TO: Mayor Andre Dickens, City of Atlanta
ATTN TO: Monique Forte, Planner III, City of Atlanta
FROM: Mike Alexander, Director, ARC Center for Livable Communities
RE: Development of Regional Impact (DRI) Review

Name of Proposal: 1400 Murphy DRI 3716

Description: A DRI review of a proposal to build 614,036 SF of industrial warehouse space in two buildings on an approximately 31.5-acre site adjacent to the Oakland City MARTA rail station. The site was previously a biscuit factory and is bounded on the south by single-family homes and the east by Sylvan Middle School. There is a dedicated MARTA rail station entrance at the northwest corner of the site.

GSWCC CERT. LEVEL III
DRAWN BY: GFL
DESIGNED BY: MEM
REVIEWED BY: ZLR
DATE: 05/27/2022
PROJECT NO: 013040011
TITLE: DRI SITE PLAN

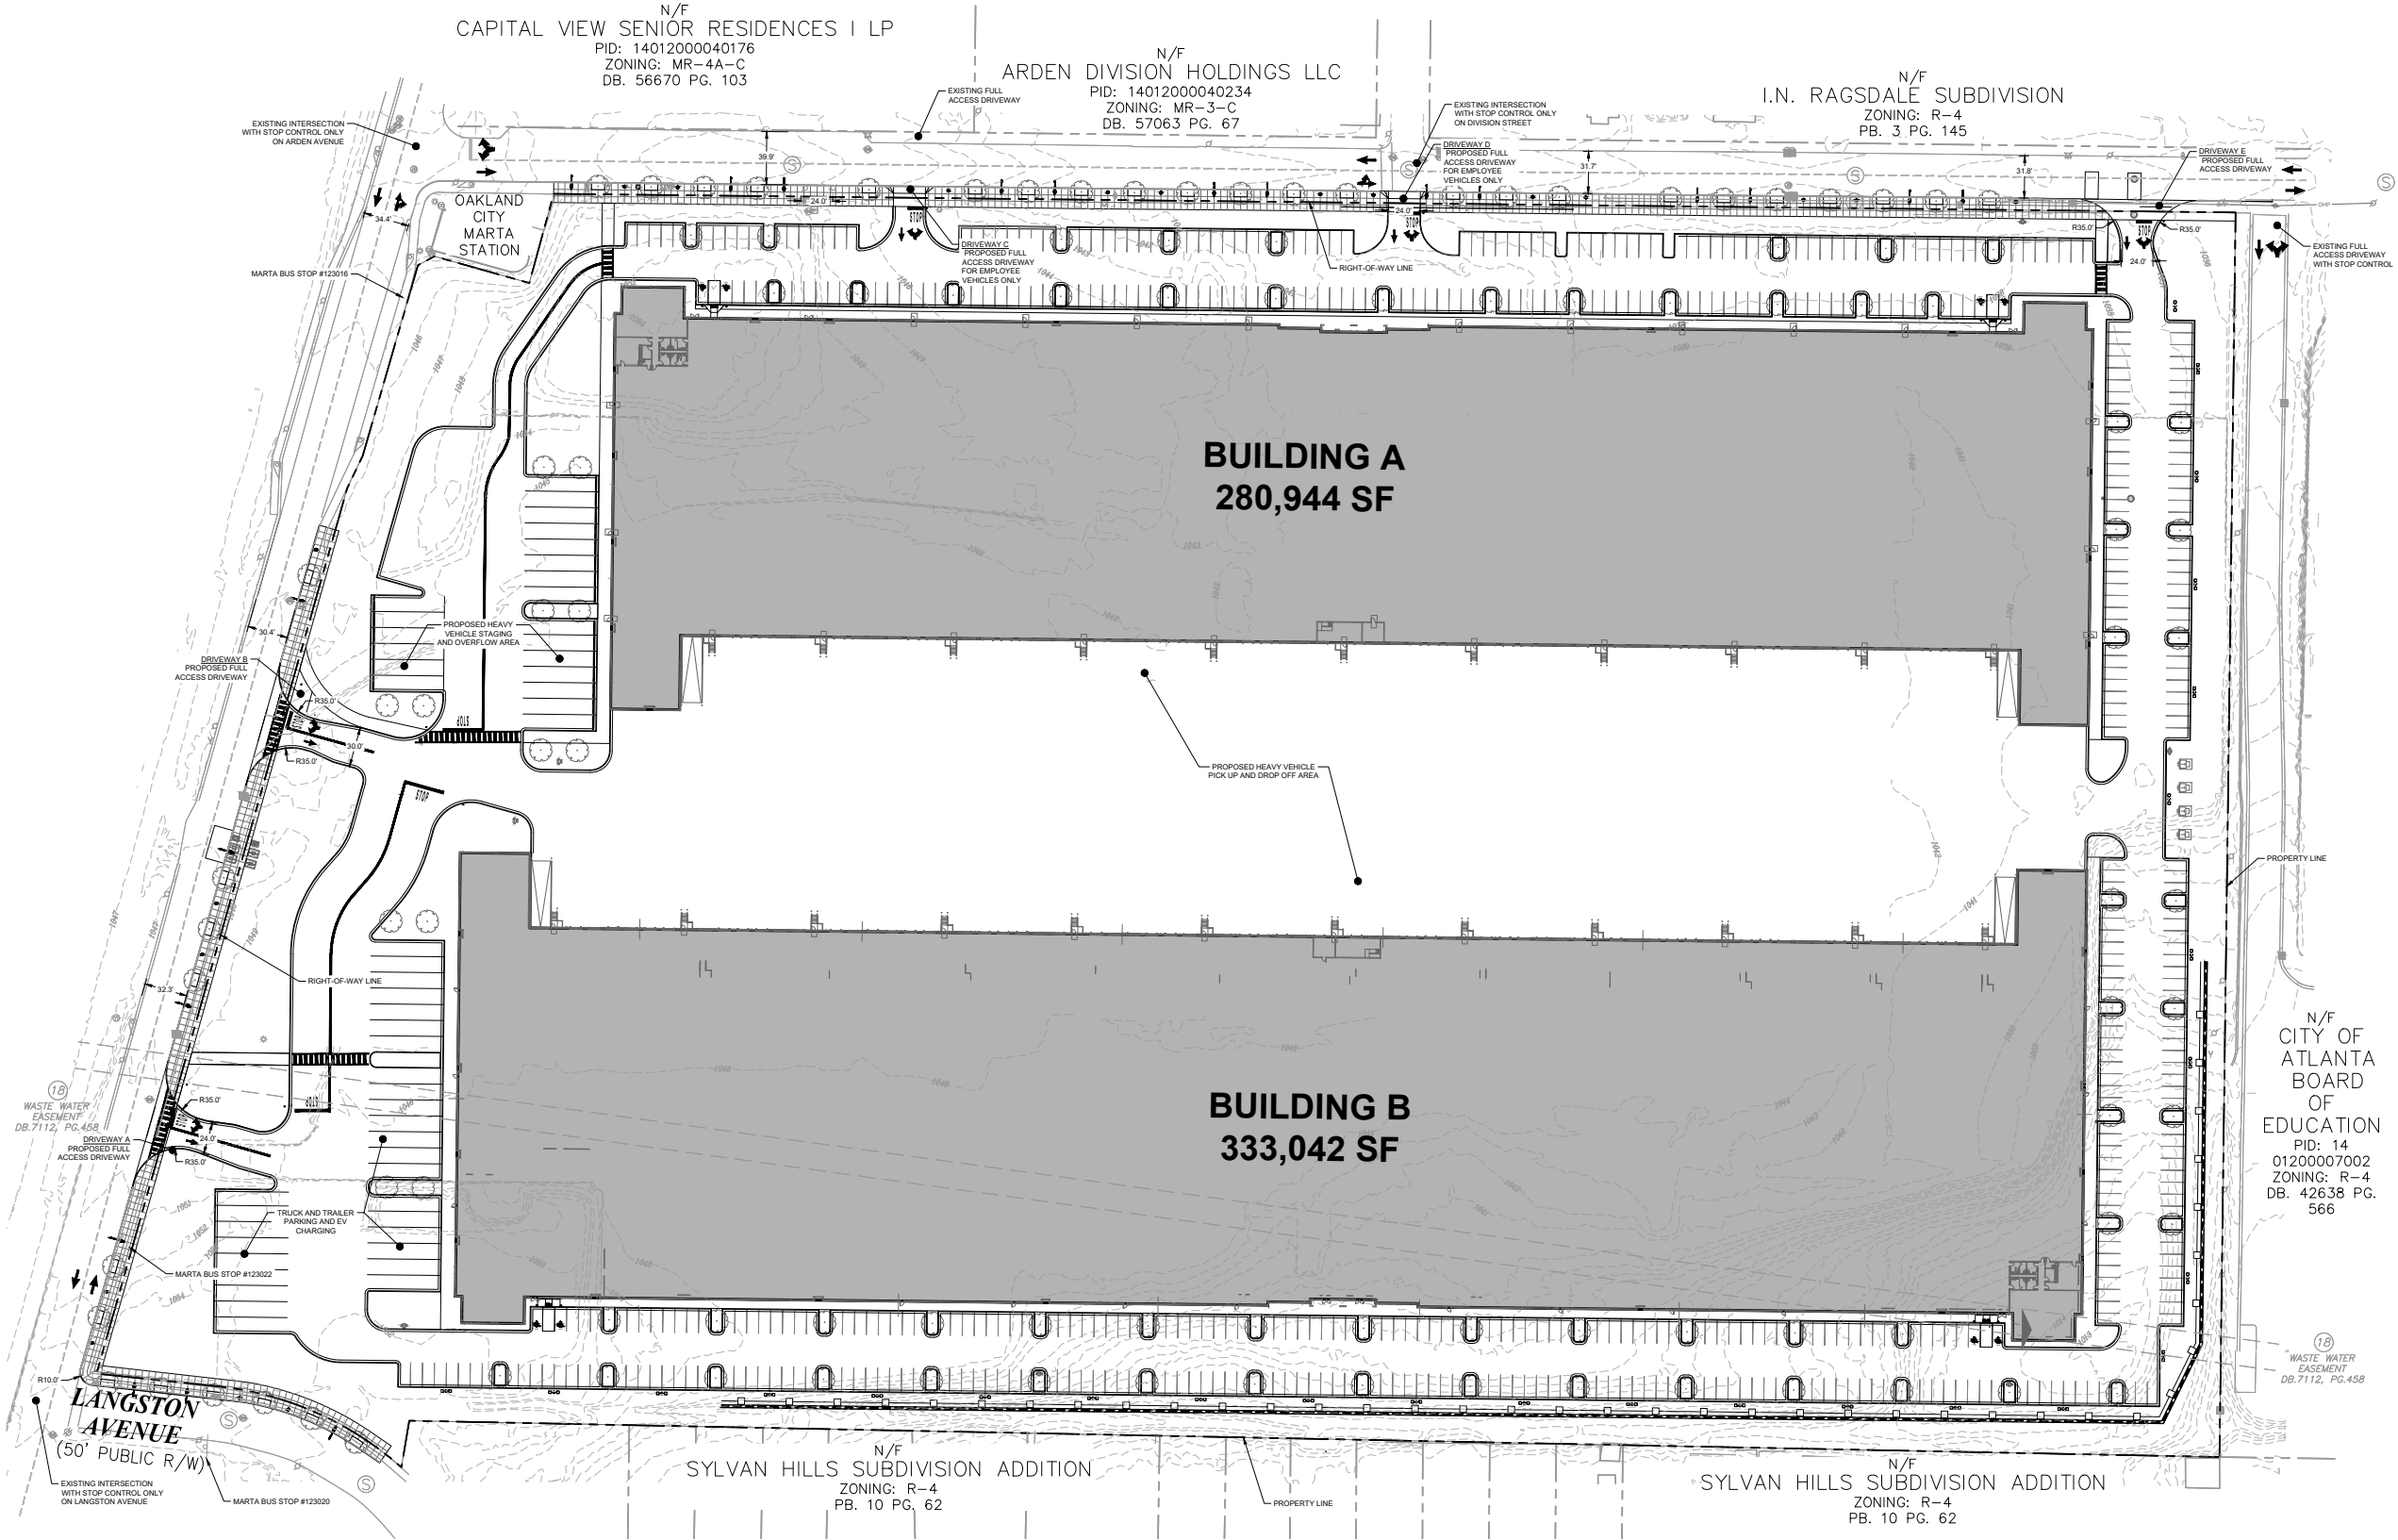
Extend sidewalk improvements along the site frontage on the Northwest corner, up to Oakland City MARTA station entrance

Show all curb ramps – Langston Ave, Driveway A, B, and E. Also, internal site curb ramps need to be shown to provide an accessible path.

Pavement resurfacing (maybe even with concrete) will be needed along Murphy Ave (between Dill and Langston) and Arden Ave (between Murphy and the existing school driveway)

Traffic calming along Arden Ave (Cycle Atlanta 2.0 – cross section OC 2.1 – proposes Arden Ave as a Neighborhood greenway), so addition of speed tables, signage/pavement markings, etc.

Consider a raised intersection at Arden Ave and Murphy Ave, since this is right at the MARTA station entrance.
